THE PORT AUTHORITY OF NY & NJ
PROCUREMENT DEPARTMENT
4 WORLD TRADE CENTER
150 GREENWICH STREET, 21ST FL.
NEW YORK, NY 10007

ADDENDUM # 3

To prospective Proposers on RFI # 55144: Solar Energy Development and Community Solar at JFK Long-Term Parking Lot:

| DESIGNED BY DES | DRAWN BY L. ZERON | CHECKED BY | | MEDIUM VOLTAGE SUBSTATIONS | Contract Number _____ | Workorder Number _____ |

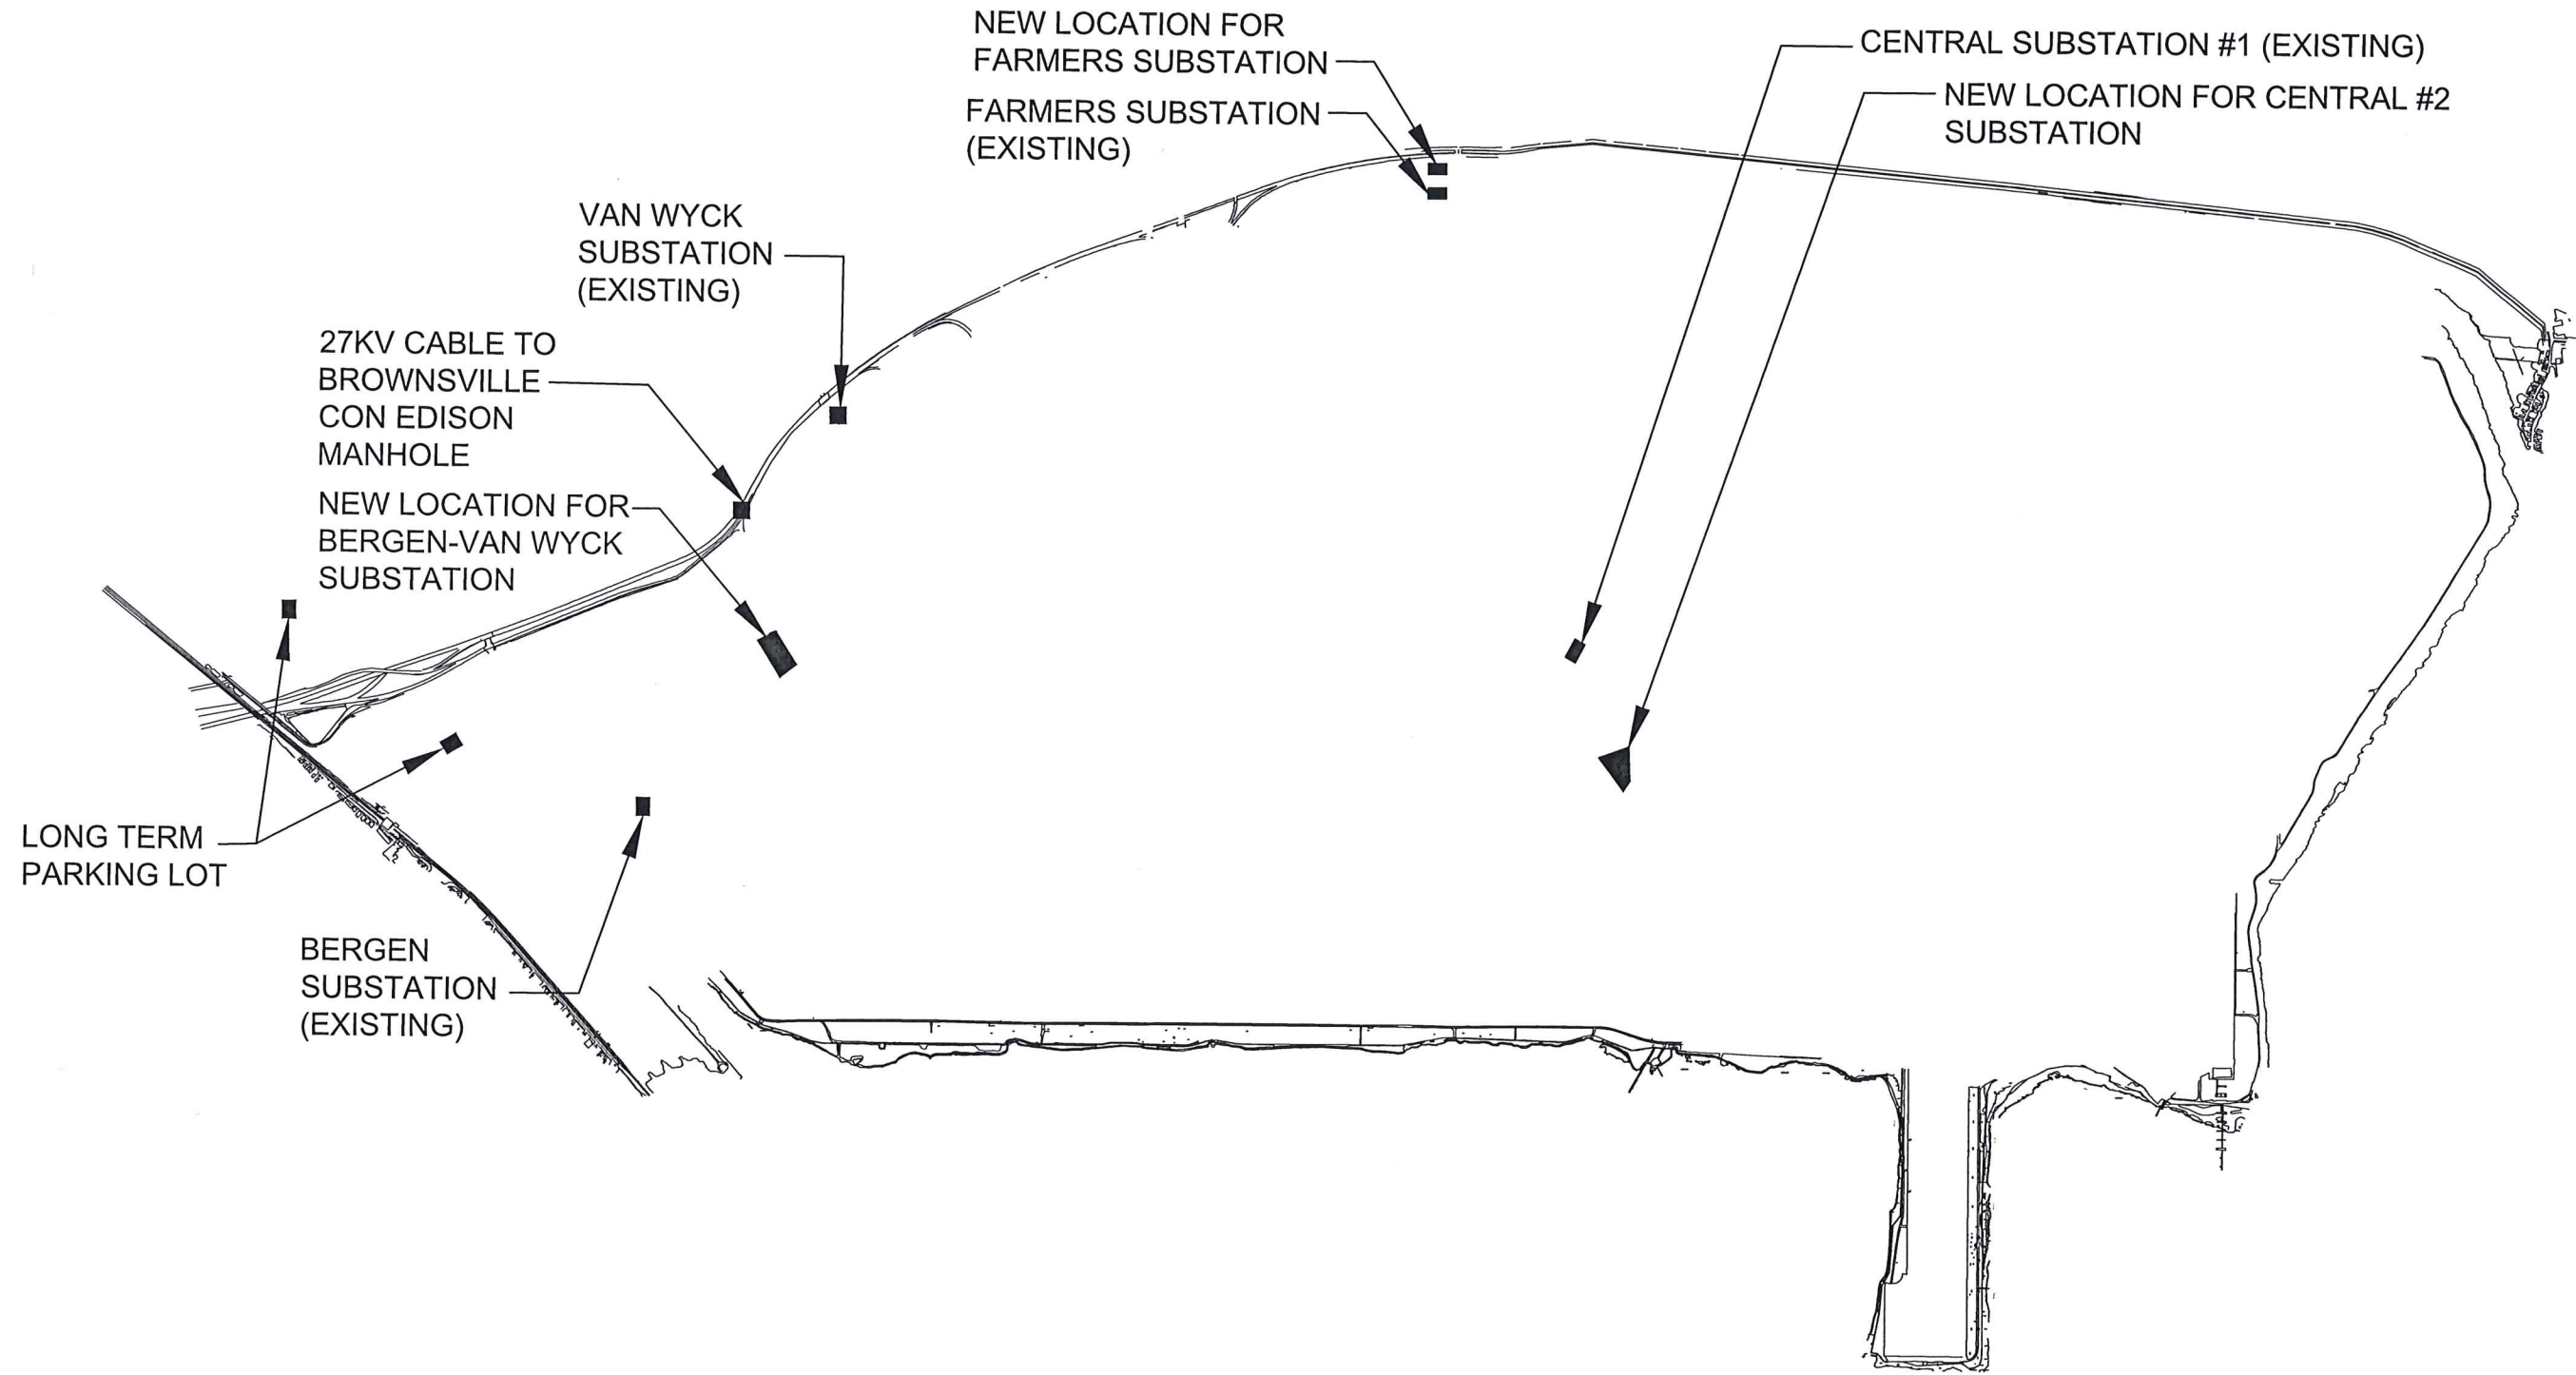
- Q7. Can the Port Authority provide the location of the Con Edison “27Kv Manhole”?
- A7. Please see the attached schematic which identifies the relative location of potential points of interconnection (including all JFK substations) in relation to the Long Term Parking Lot. A detailed map cannot be provided. For reference, the straight line distance between the Con Ed 27 kV manhole and the 5 kV substation at the Long Term Parking Lot is approximately 0.7 miles.

- Q12. Can you elaborate on the future infrastructure changes happening at the Van Wyck substation? We would like to understand how this might potentially affect the solar interconnection.

- A12. The existing Van Wyck and Bergen substations will be combined into one new substation (approximate anticipated completion date in 2022). The location of the new Bergen/VanWyck substation is shown on the attached schematic.
